PROJECT #: 24-1421.1-B
KOSLOWSKY RESIDENCE
BAPTIST GROVE RD
RE: HANGER SUBSTITUTION
AND NOTCHED BEAM

Partial Sheet S-2

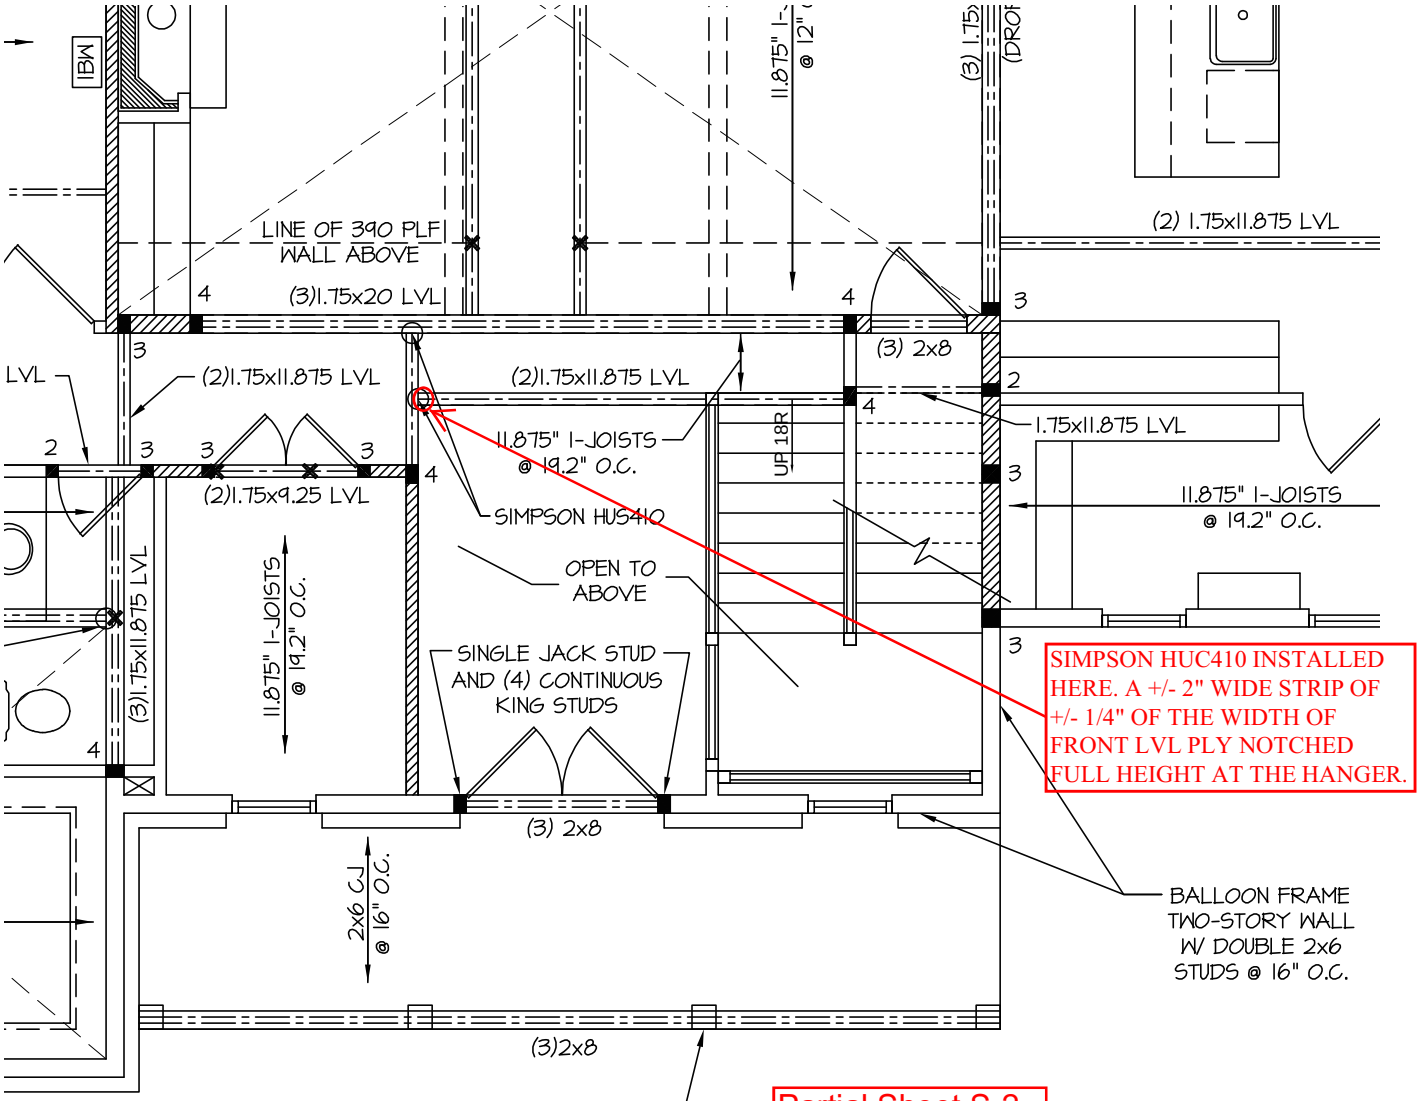
SIMPSON HUC410 INSTALLED HERE. A +/- 2" WIDE STRIP OF +/- 1/4" OF THE WIDTH OF FRONT LVL PLY NOTCHED FULL HEIGHT AT THE HANGER.

THE NOTED HANGER SUBSTITUTION AND NOTCH IN THE LVL ARE STRUCTURALLY ADEQUATE
